# TOLEDO-LUCAS COUNTY PLAN COMMISSIONS

REF: SUP-5002-19

SUBJECT: Special Use Permit for a Hospital

Request	-	Special Use Permit for a Hospital
Location	-	3837 Secor Road
Applicant	-	Encompass Health 9001 Liberty Parkway Birmingham, AL 35242
Owner	-	Rick Landrum The Kroger Company 1014 Vine Street Cincinnati, OH 45202
Engineer	-	Jeff Myers The Mannik & Smith Group 1800 Indian Wood Cir Maumee, OH 43537

# SITE PLAN

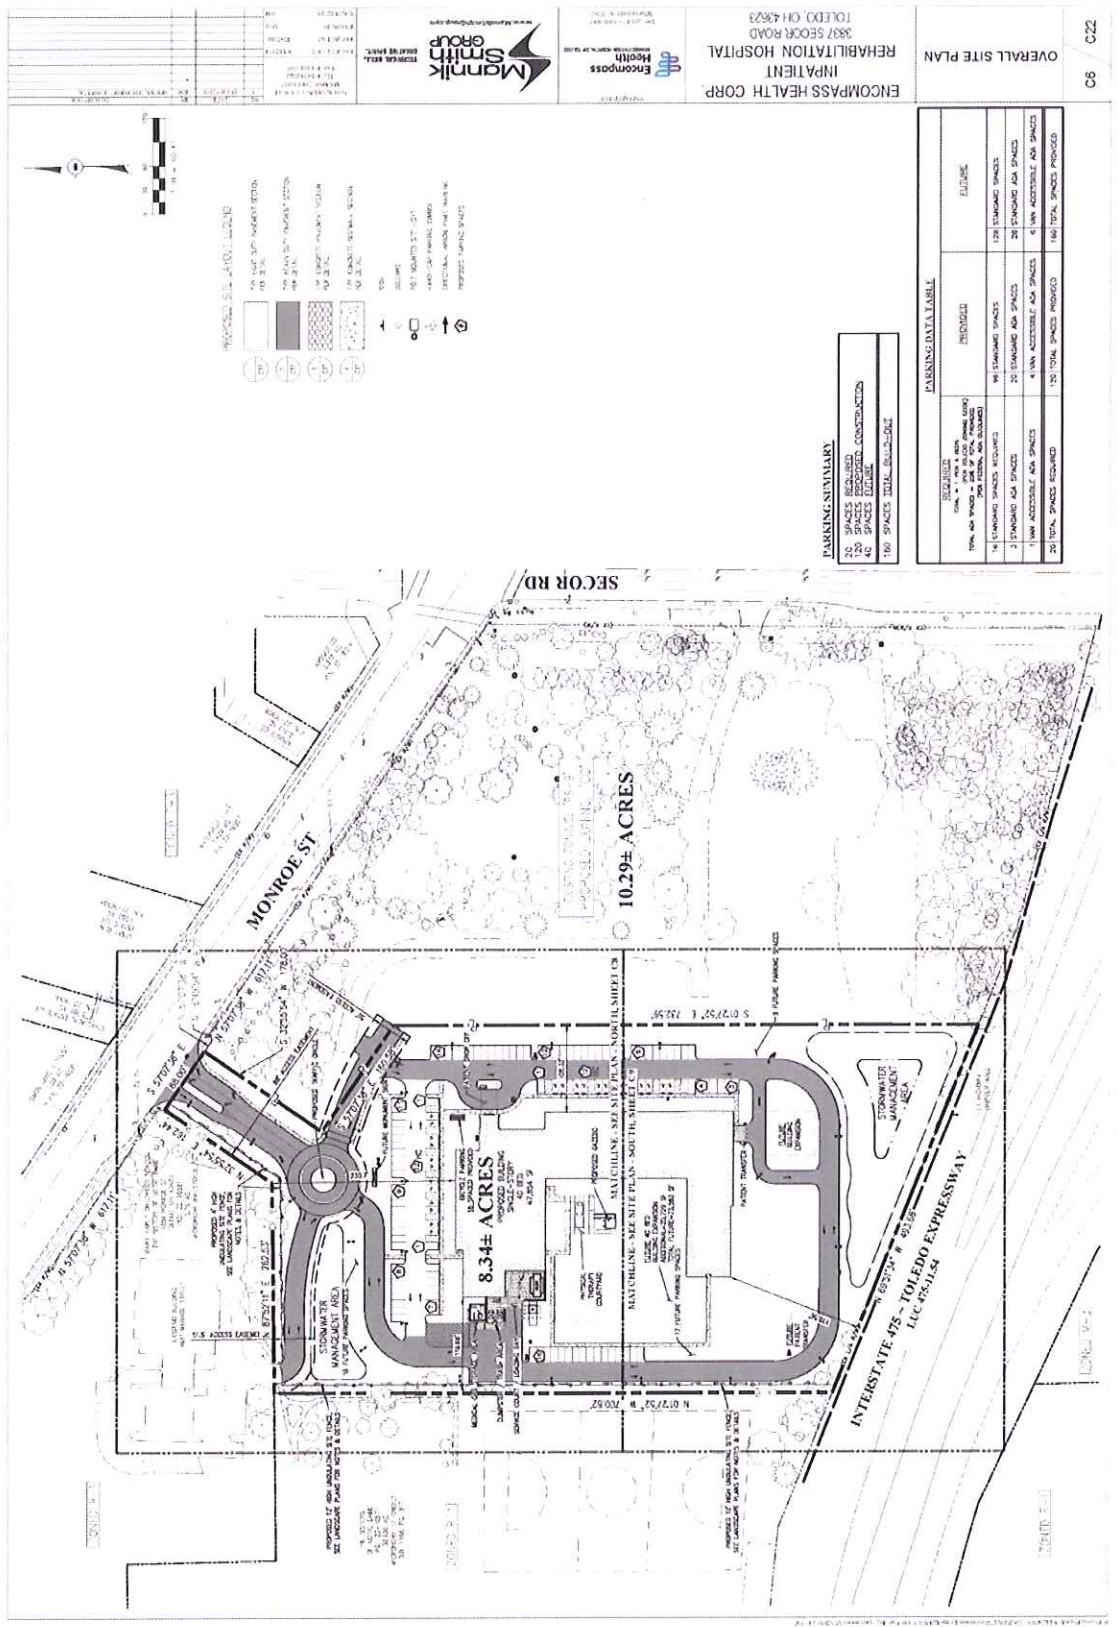
The applicant is proposing to build a 40 bed, single-story, 47,854 sq. ft. hospital focusing on rehabilitation services with a 120 space parking lot. The plan includes an optional building addition of 25,729 sq. ft., 40 beds and 40 parking spaces. The facility will have a staff of 88 over two shifts with the potential to increase staffing to 125 full time jobs. A twelve (12) foot screening wall is provided along the western property line and exceeds the maximum ten (10) foot height allowed in the CO zoning district. The fence height was part of an agreement reached between Encompass and Notre Dame Academy. A waiver of the maximum fence height is required and is included as a condition of approval. The fence has been reduced to four (4) feet along the day care property. Staff is supportive of the waiver as proposed.

The facility will be accessed from Monroe Street at a non-signalized intersection. A shared access easement will cover the entrance of the site to accommodate the existing day care and future development to the east as additional access points will be prohibited. The portion of the public sidewalk along Monroe Street will be widened to accommodate the relocation of the sidewalk in order to address safety concerns when the adjacent property is developed. The applicant also provided a landscape median at the Monroe Street entrance in order to improve pedestrian safety.

A hospital is required to provide one (1) parking space per four (4) beds. The site is providing a potential total of 160 parking spaces. The maximum parking allowed on the property is 30 parking spaces if all 80 beds are considered. A review of other large communities in Ohio suggests that Toledo requirements are on the low side of other communities and is an item that will be reviewed in greater detail in the future. An alternative parking plan was submitted by the applicant and approved by this office. The applicant indicated that the parking needs are based on other Encompass Health facilities throughout the United States.

The landscape plan provides a Type A buffer to the west, perimeter and interior parking lot landscape, and foundation plantings. A frontage greenbelt is not required on this property due to limited parcel frontage on Monroe Street. The plan has been revised and is compliant with all landscaping requirements except for the fencing for the Type A buffer to the south. A waiver is required as a condition of approval. Staff is supportive of the waiver provided the ODOT sound wall remain. If it is removed adequate fencing shall be installed. The stormwater area to the south has been reshaped to provide additional visual interest and accommodate additional landscaping elements. The northern stormwater area closer to Monroe Street is being examined for ways to incorporate best management practices.

Approve a waiver of **TMC 1105.0302.A.2** to allow twelve (12) foot fencing along the western property line, and around the gas storage area, provided the fence height is reduced to a maximum of four (4) feet along the day care property.

Approve a waiver of **TMC 1108.0203.C.** to allow for the elimination of fencing provided the ODOT sound wall remains.
